**From:** Kris Lafko <KrisLa@linxtechnologies.com>  
**Sent:** Wednesday, May 31, 2017 10:07 AM  
**To:** Pcn System  
**Subject:** PCN# 53841- Updated Linx Cable Assembly Drawings  
**Attachments:** WinZip Compressed Attachments.zip

In performing a recent documentation audit we have found that some updated drawings and documents have not been fully distributed, so we will be sending out updates in the next week in order to attempt to make sure the most current documentation is in your library and web sites where appropriate. For the first update, please find attached the updated drawings for five cable assembly design; for the following part numbers:

Linx Part Number
CSI-RGFB-ccc-UFFR
CSI-RSFB-ccc-UFFR
CSI-RSFE-ccc-UFFR
CSI-SAFB-ccc-UFFR
CSI-SAFE-ccc-UFFR

SIZE DWG. NO. REV  
**B** CSI-SAFE-ccc-UFFR **C**

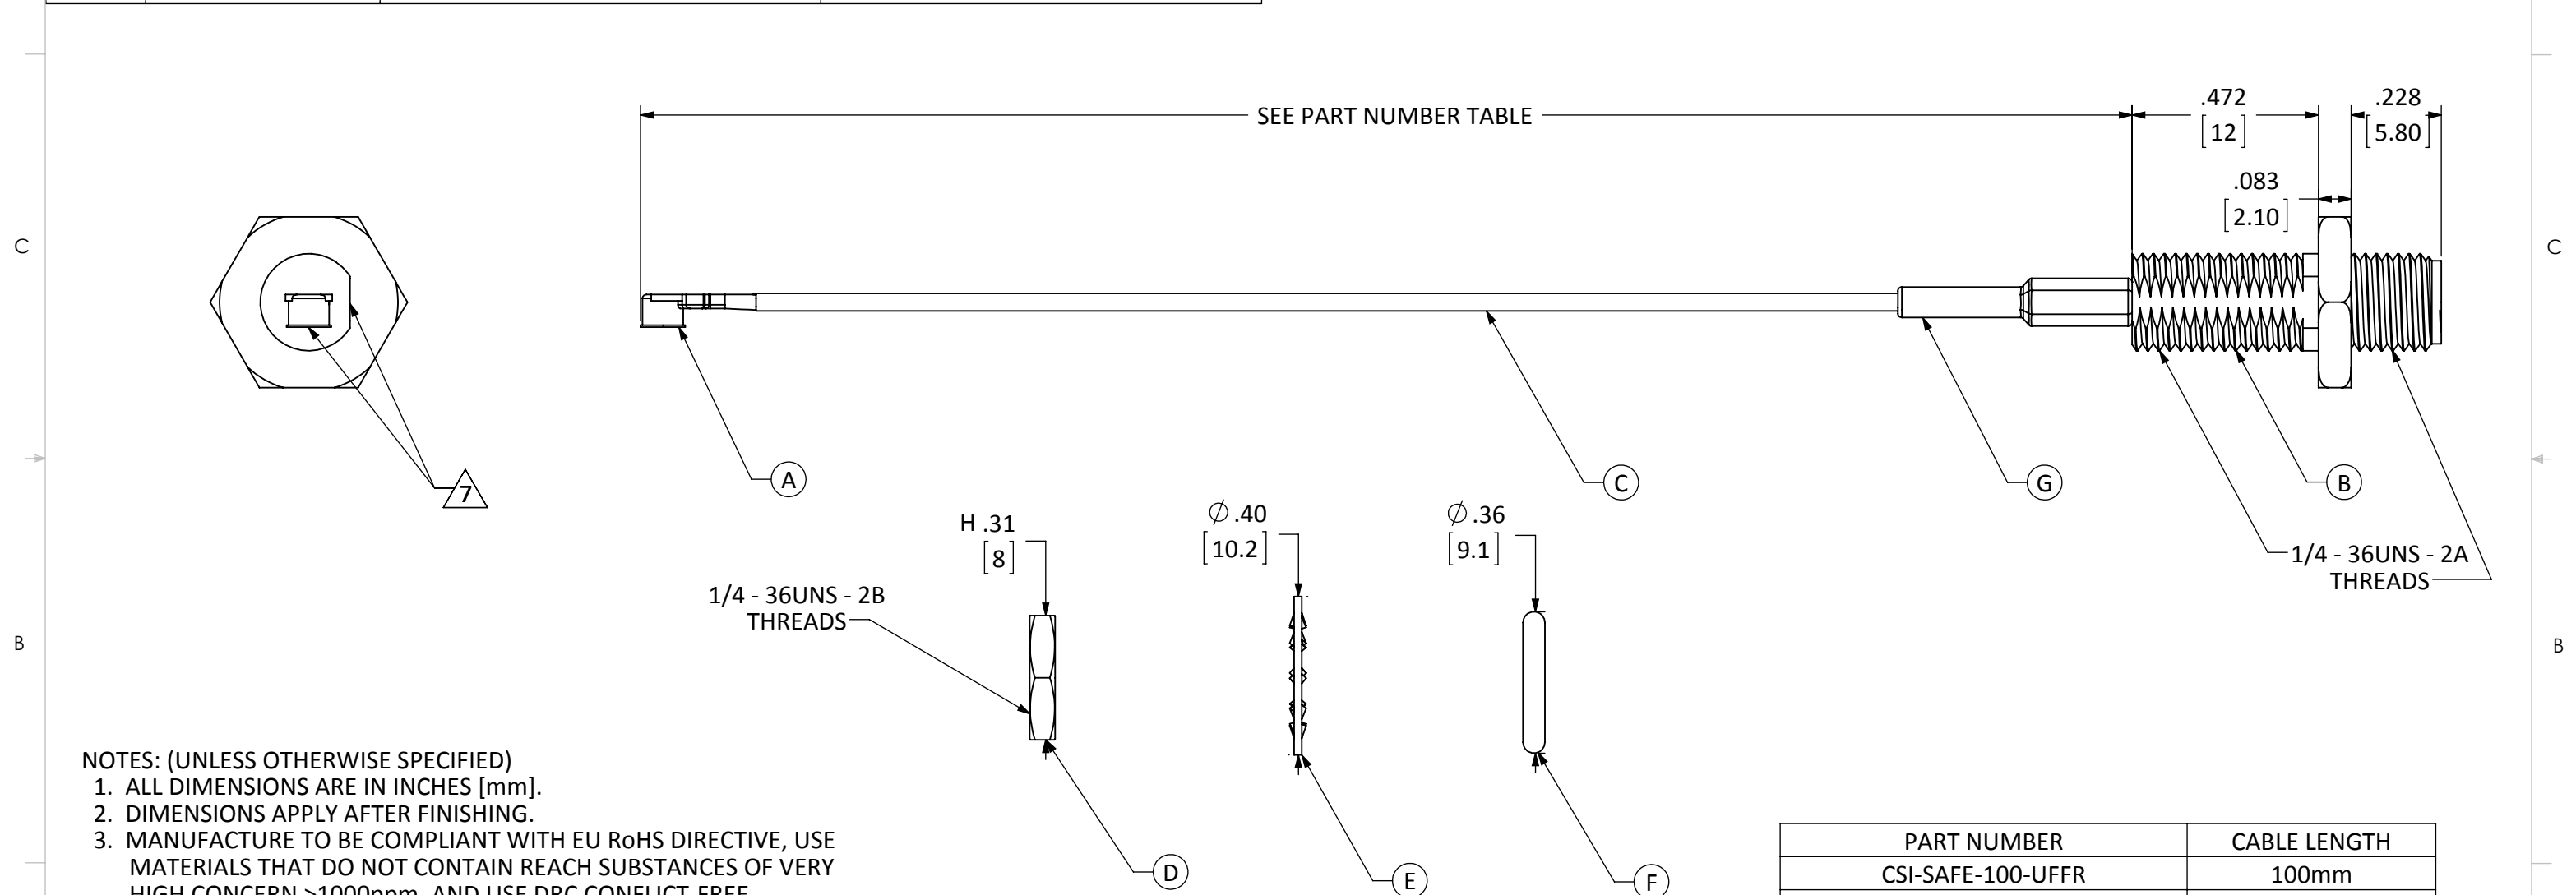
REVISIONS			
REV	DESCRIPTION	DATE	APPV
A	INITIAL RELEASE OF LINX INTERNAL DRAWING	15-APR-14	SAH
B	UPDATED NOTE 3; ADDED FLAG NOTE 7 AND VIEW TO ILLUSTRATE CONNECTOR ORIENTATION	1-SEP-15	SAH
C	UPDATED TO ADD DIMENSIONS TO NUT, WASHER AND O-RING	13-JUL-16	SAH

SIZE	DWG. NO.	REV
<b>B</b>	CSI-SAFB-ccc-UFFR	<b>C</b>
SCALE: 2.5:1	DO NOT SCALE DRAWING	SHEET 1 OF 1

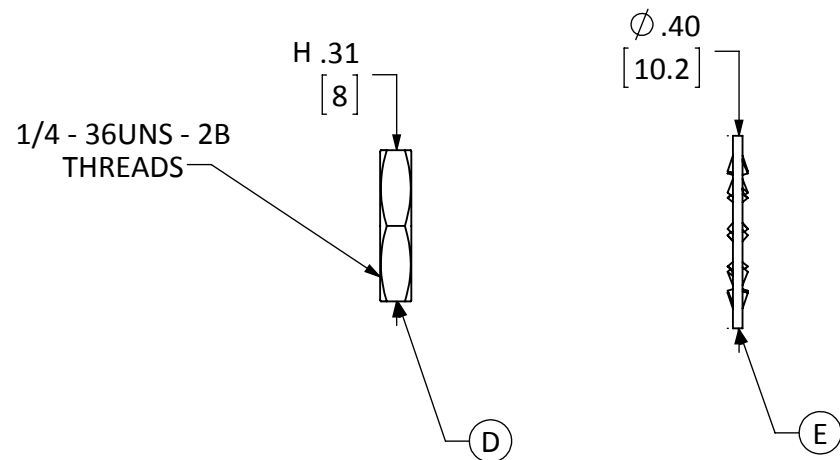
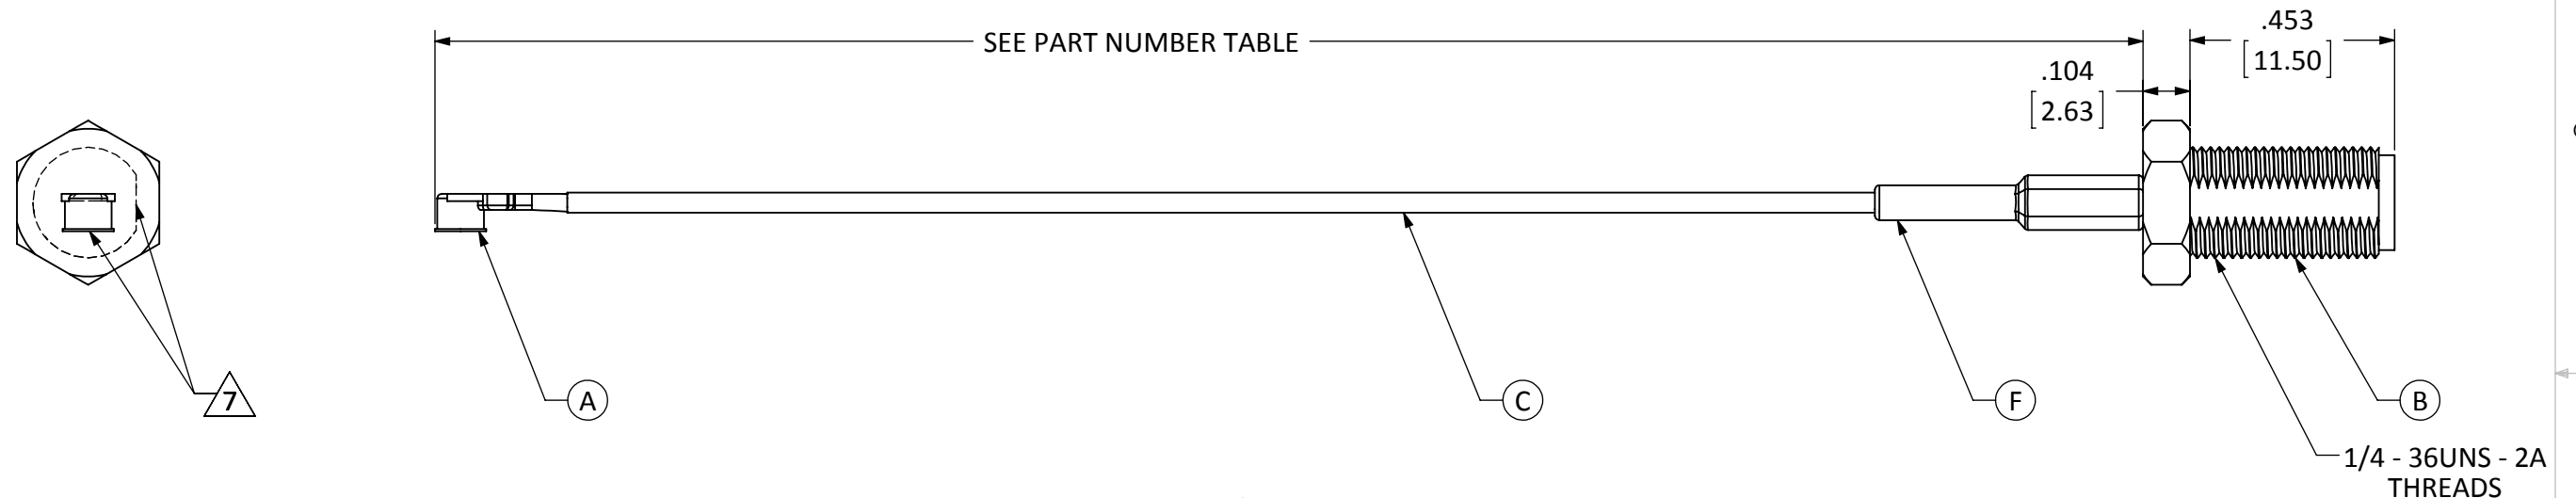
REVISIONS			
REV	DESCRIPTION	DATE	APPV
A	INITIAL RELEASE OF LINX INTERNAL DRAWING	15-APR-14	SAH
B	UPDATED NOTE 3; ADDED NOTE 5; ADDED FLAG NOTE 7 AND VIEW TO ILLUSTRATE CONNECTOR ORIENTATION; ADDED DIMENSIONS; UPDATED DESCRIPTION TABLE	1-SEP-15	SAH
C	UPDATED TO ADD DIMENSIONS TO NUT AND WASHER	13-JUL-16	SAH

SIZE DWG. NO. REV  
**B** CSI-RSFE-ccc-UFFR **C**

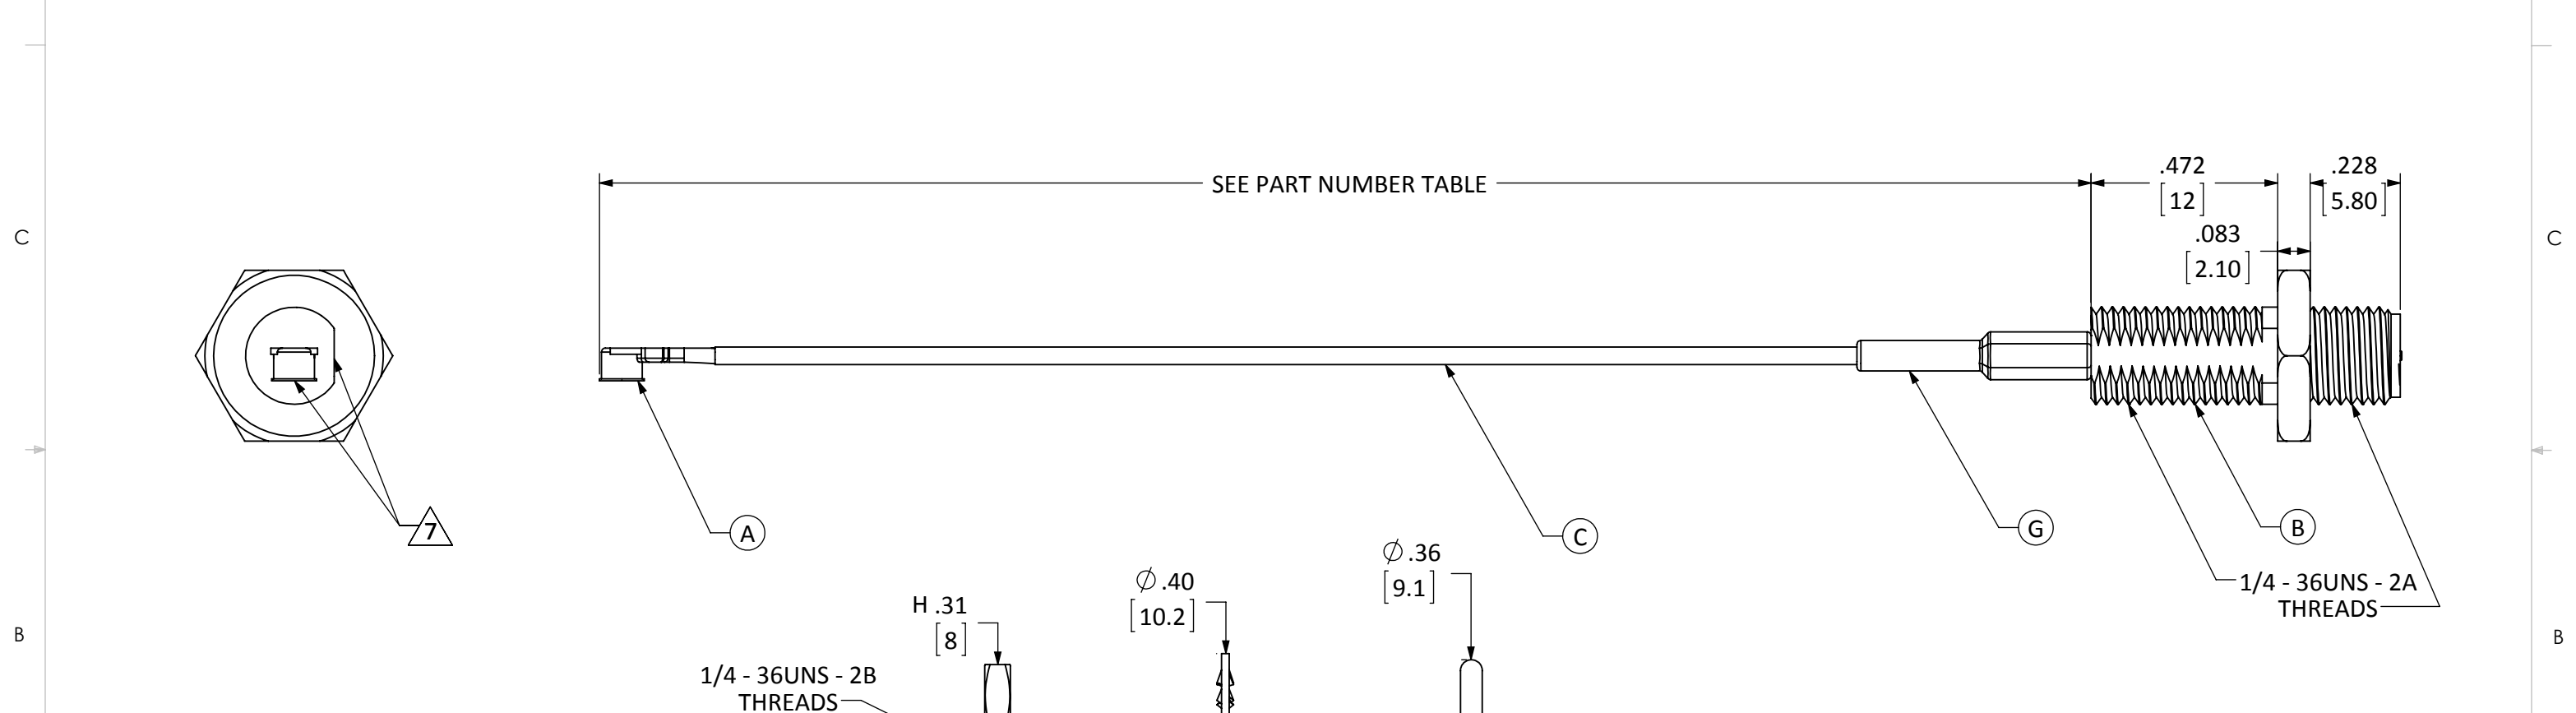
REVISIONS			
REV	DESCRIPTION	DATE	APPV
A	INITIAL RELEASE OF LINX INTERNAL DRAWING	15-APR-14	SAH
B	UPDATED NOTE 3; ADDED NOTE 5; ADDED FLAG NOTE 7 AND VIEW TO ILLUSTRATE CONNECTOR ORIENTATION; ADDED DIMENSIONS; UPDATED DESCRIPTION TABLE	1-SEP-15	SAH
C	UPDATED TO ADD DIMENSIONS TO NUT, WASHER AND O-RING	13-JUL-16	SAH

SIZE DWG. NO. REV  
**B** CSI-RSFB-ccc-UFFR **C**

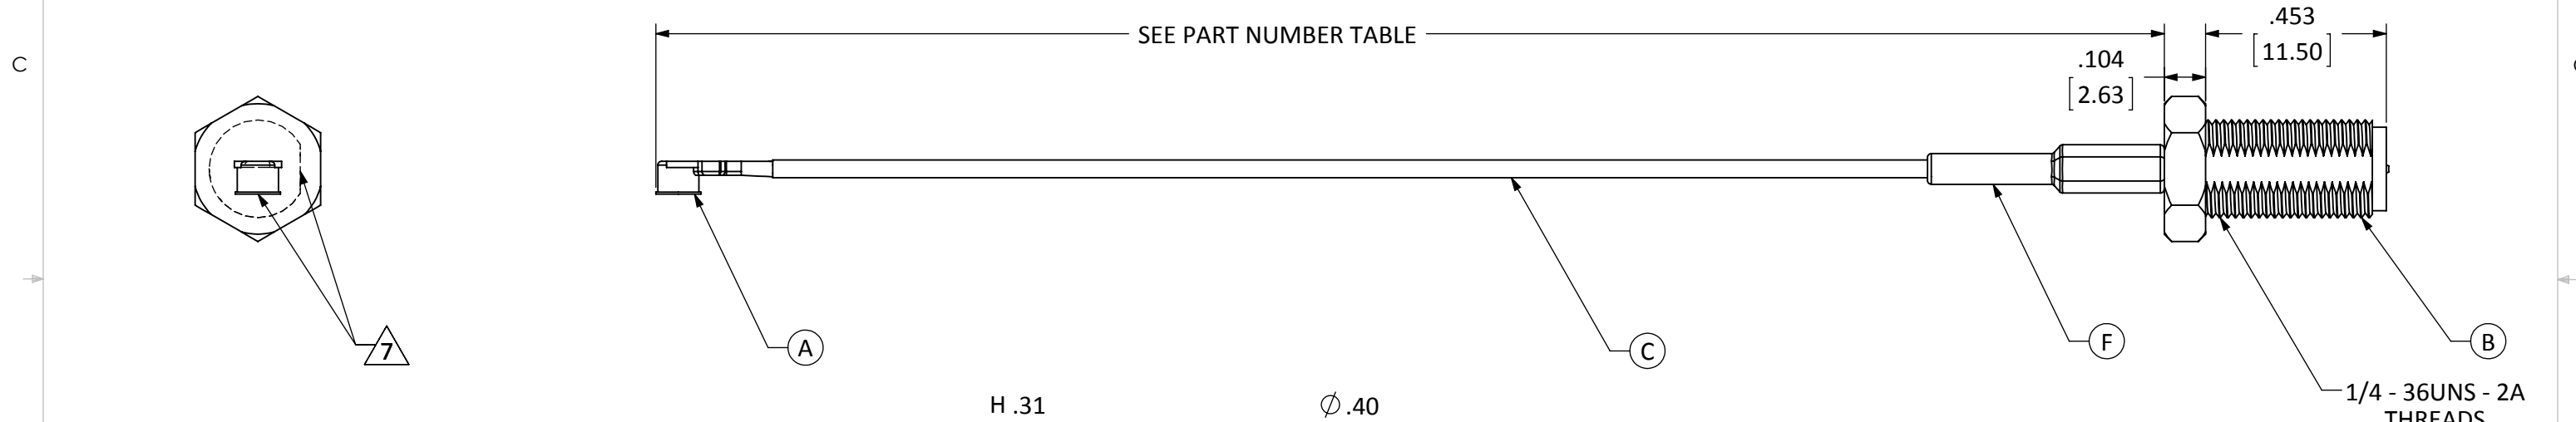
REVISIONS			
REV	DESCRIPTION	DATE	APPV
A	INITIAL RELEASE OF LINX INTERNAL DRAWING	15-APR-14	SAH
B	UPDATED NOTE 3; ADDED FLAG NOTE 7 AND VIEW TO ILLUSTRATE CONNECTOR ORIENTATION; ADDED DIMENSIONS; UPDATED DESCRIPTION TABLE; ADDED NOTE 5	1-SEP-15	SAH
C	UPDATED TO ADD DIMENSIONS TO NUT AND WASHER	13-JUL-16	SAH

SIZE	DWG. NO.	REV
<b>B</b>	CSI-RGFB-ccc-UFFR	<b>C</b>
SCALE: 2.5:1	DO NOT SCALE DRAWING	SHEET 1 OF 1

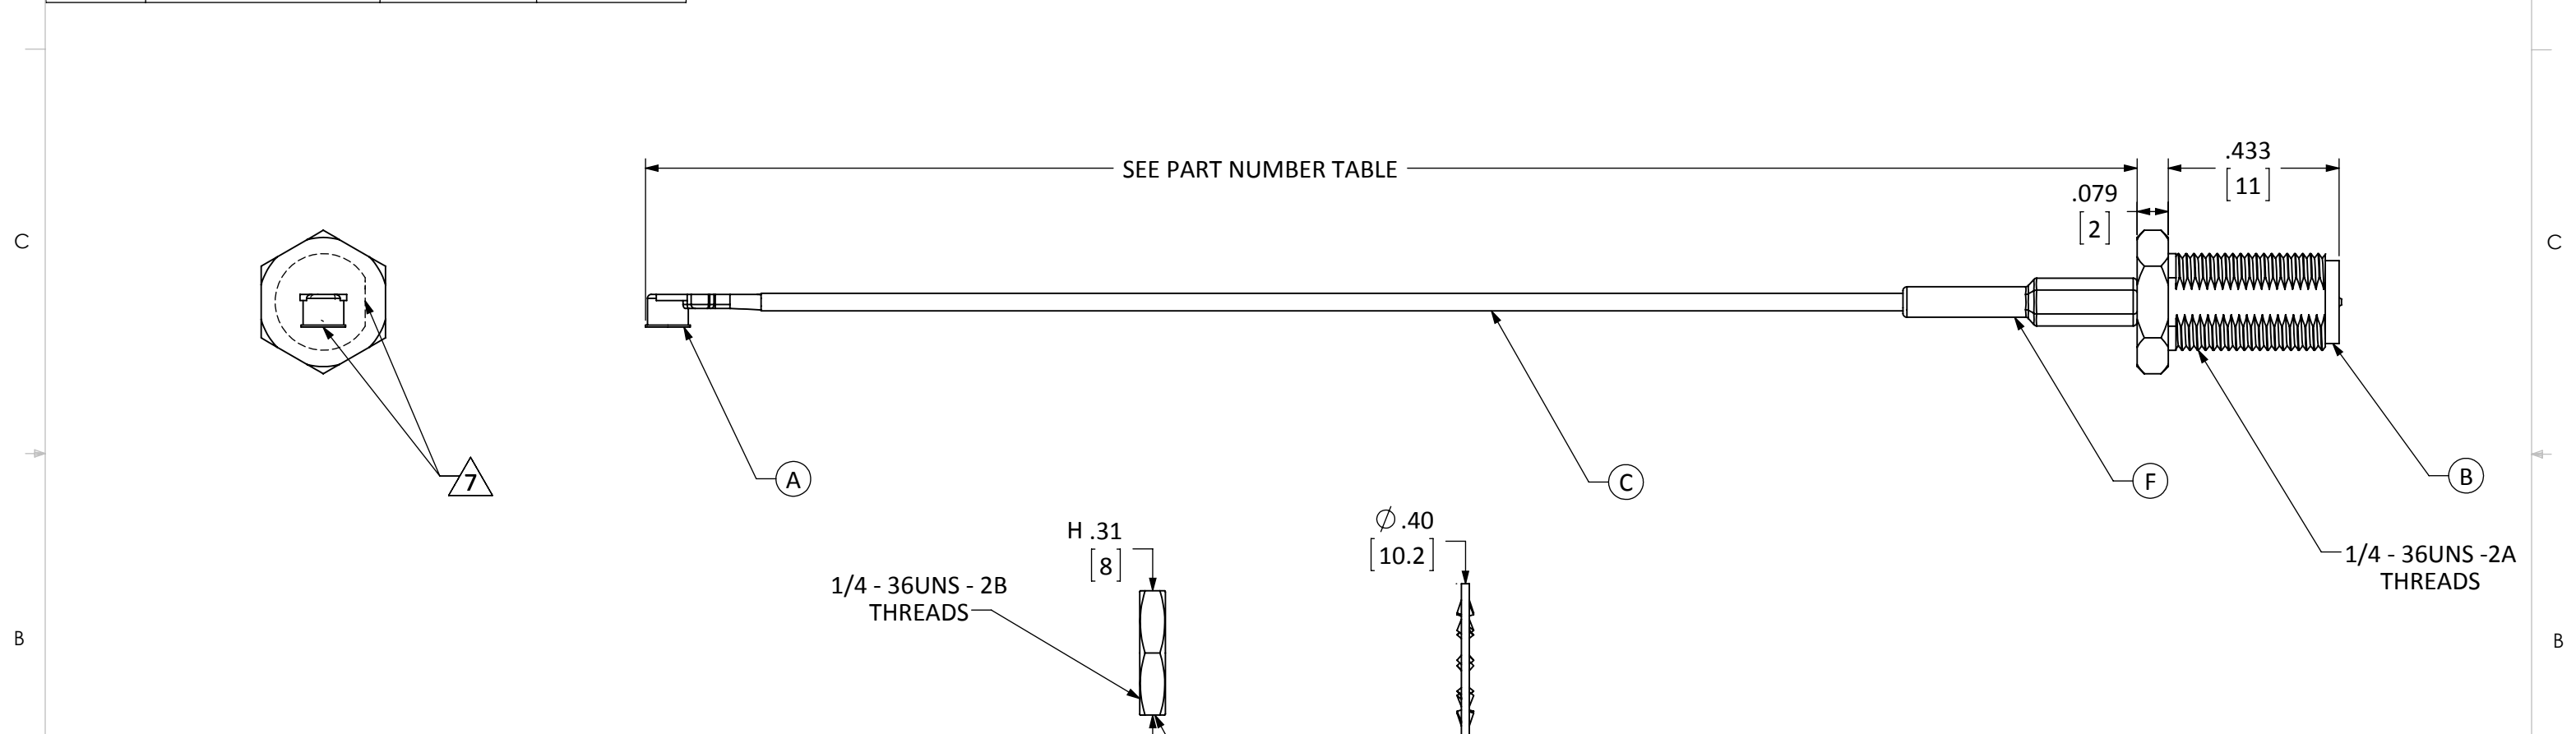
REVISIONS			
REV	DESCRIPTION	DATE	APPV
A	INITIAL RELEASE OF LINX INTERNAL DRAWING	14-MAY-15	SAH
B	UPDATED NOTES NUMBERING; UPDATED NOTE 5; ADDED FLAG NOTE 7 AND VIEW TO ILLUSTRATE CONNECTOR ORIENTATION; ADDED DIMESIONS; UPDATED DESCRIPTION TABLE	1-SEP-15	SAH
C	UPDATED TO ADD DIMENSIONS TO NUT AND WASHER	13-JUL-16	SAH
